**REVIEW REPORT
FAULT RUPTURE HAZARD/
GEOTECHNICAL EVALUATION
PROPOSED HIGHLANDS PUD
RESIDENTIAL DEVELOPMENT
APPROXIMATELY 2670 SOUTH HIGHLAND DRIVE
SALT LAKE COUNTY, UTAH**

Job No. E95-2196

Re: Review Report
Fault Rupture Hazard/Geotechnical Evaluation
Proposed Highlands PUD Residential Development
Approximately 2670 South Highland Drive
Salt Lake County, Utah

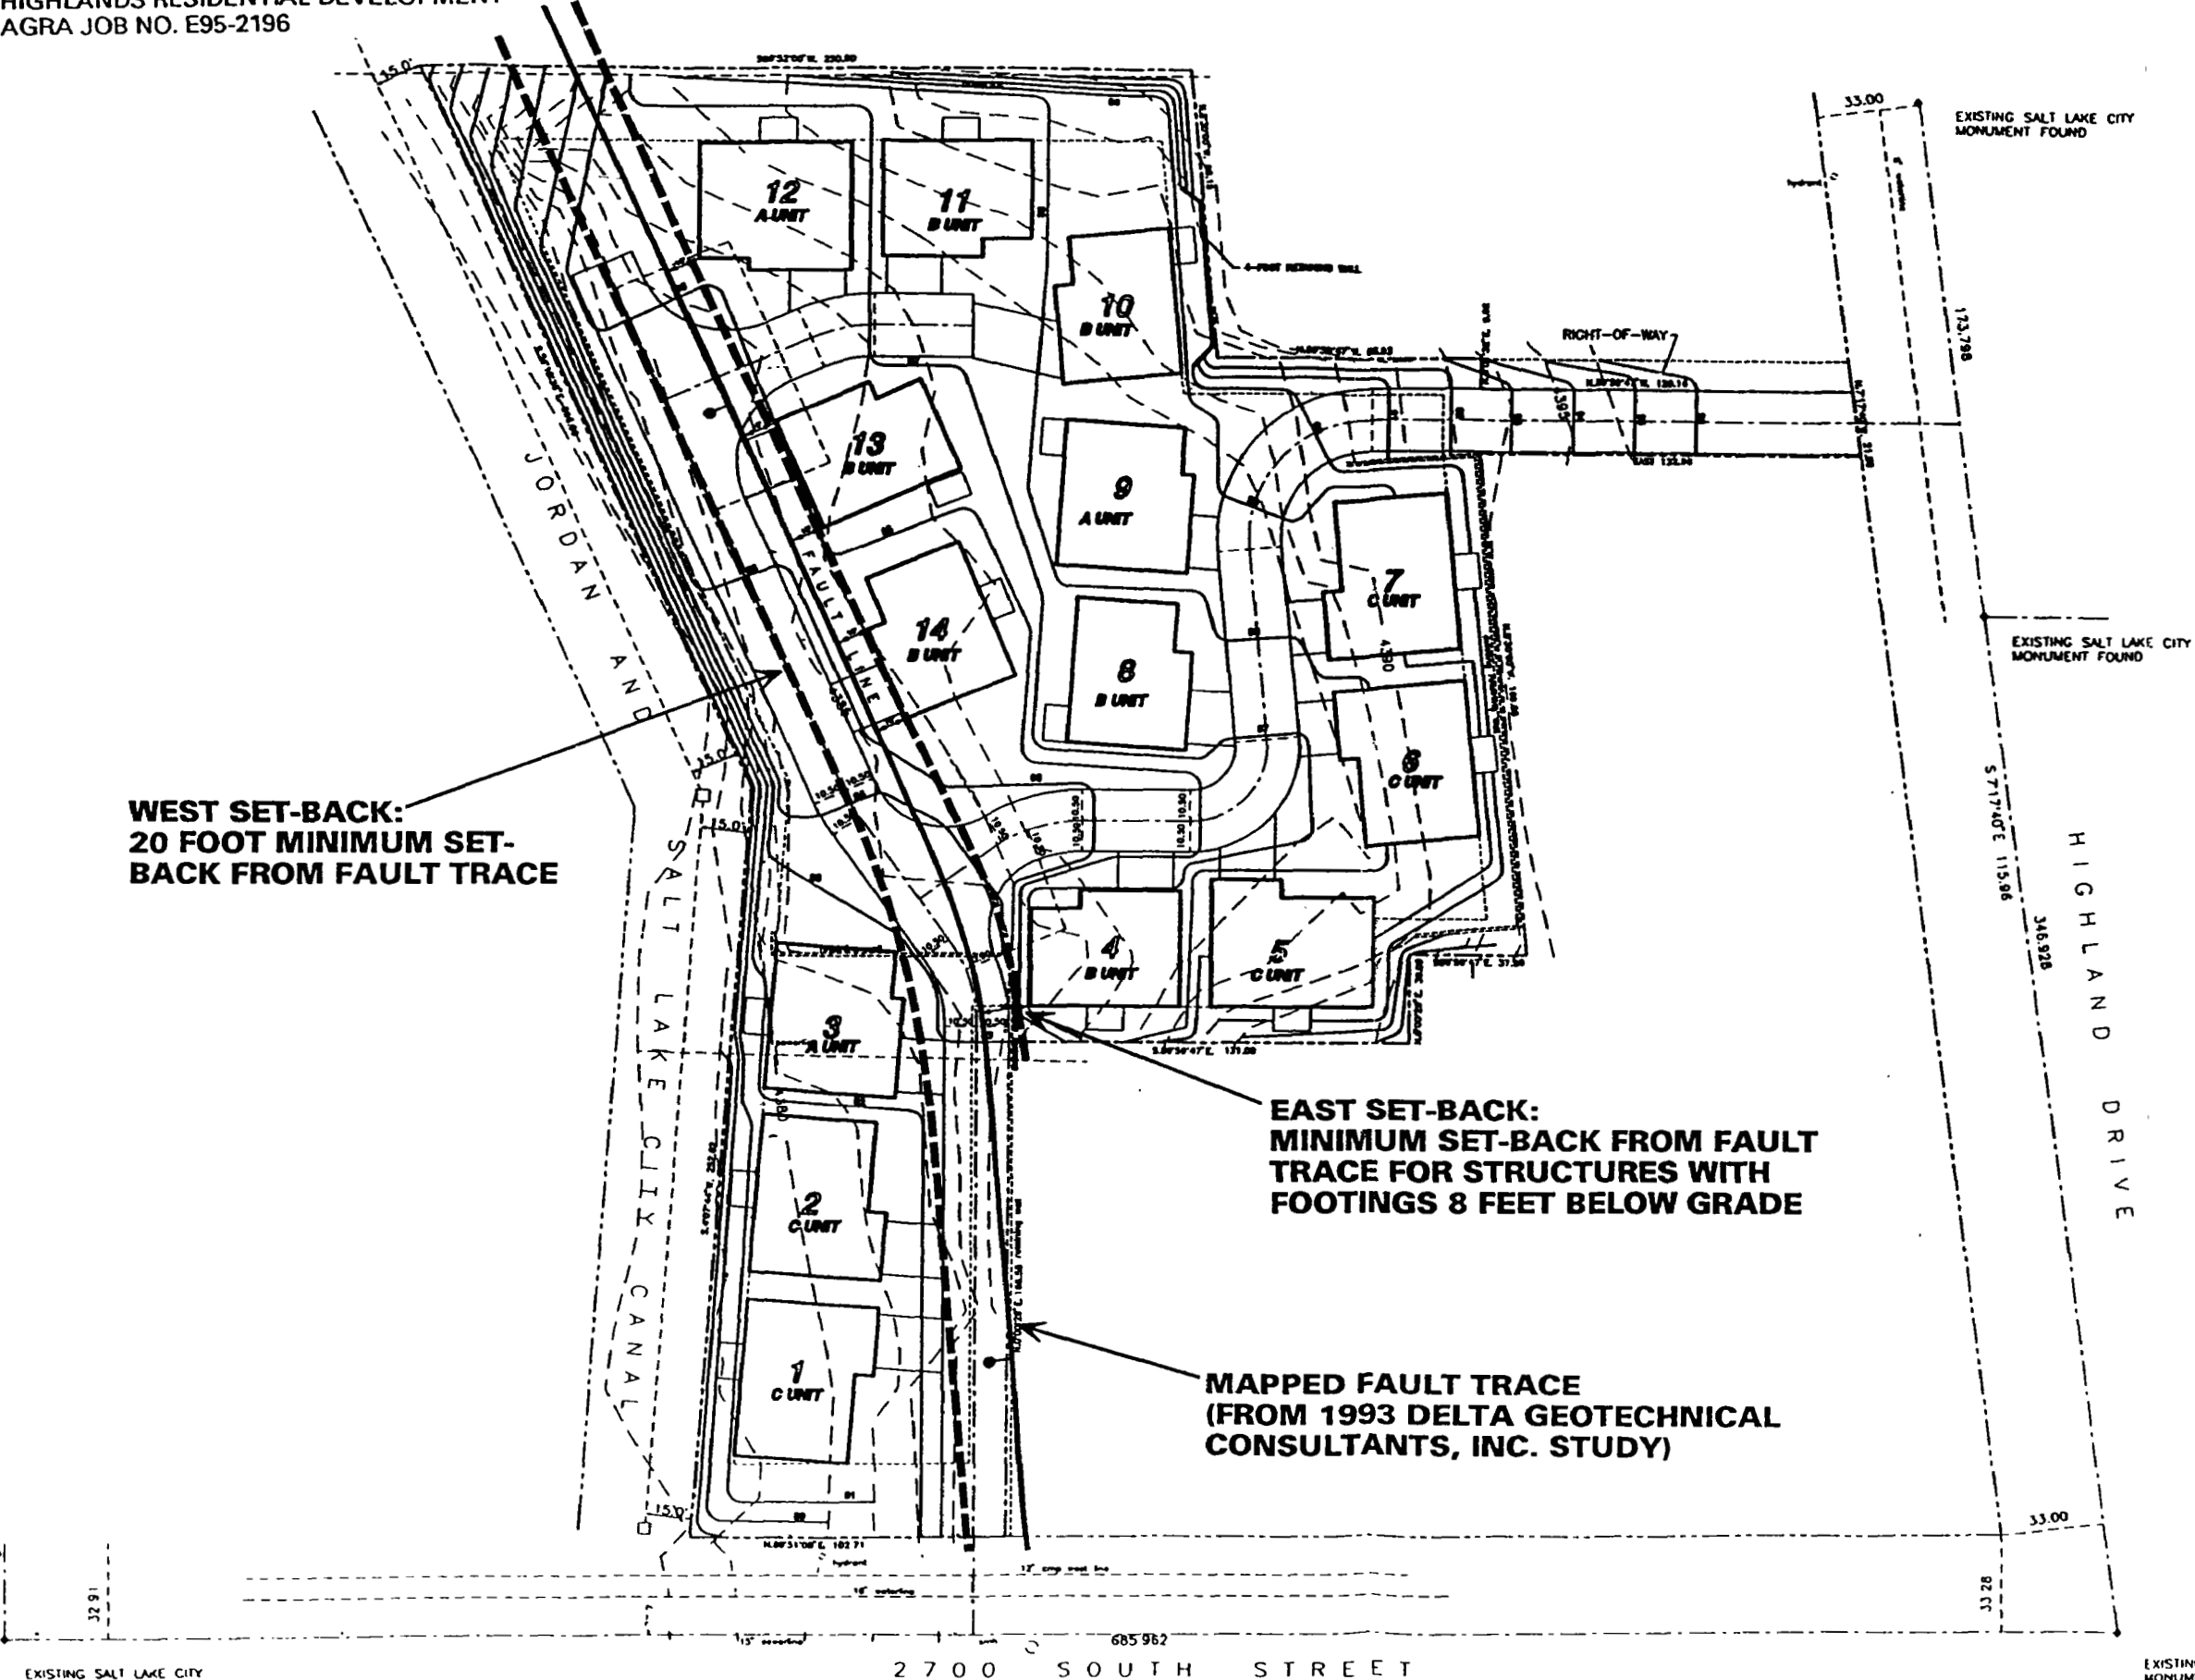
We believe that the set-backs specified by Delta for slab-on-grade structures (Appendix A), are appropriate. However, it is our understanding that the footings of structures adjacent to the east side of the faulting proposed by American Housing Development Corporation, specifically units 4, 12, 13, and 14, are to extend at least eight feet below existing grade. Because the faulting is downthrown to the west, and because the fault traces dip to the west from 71 degrees to 55 degrees, structures with below-grade footings on the east side of the faulting may be established closer than the 15-foot set-back specified for structures with slab-on-grade footings. We recommend that the footings of units 4, 12, 13, and 14, on the east side of the faulting be set-back at least 15 feet from the below-grade projection of the fault traces. This minimum set-back distance has been calculated and is shown on Figure 2 of this report.

We understand that proposed units 1, 2, and 3, which are on the west side of the faulting are to be slab-on-grade structures. Plans prepared for American Housing Development Corporation indicate that these structures will be set-back at least 20 feet to the west of the faulting. The minimum 20-foot set-back on the west side of the faulting is also shown on Figure 2.

On the basis of the information obtained from the Delta reports, we believe that if the structures proposed for the site are set-back as shown on Figure 2, that hazards related to fault rupture and deformation will be minimized.
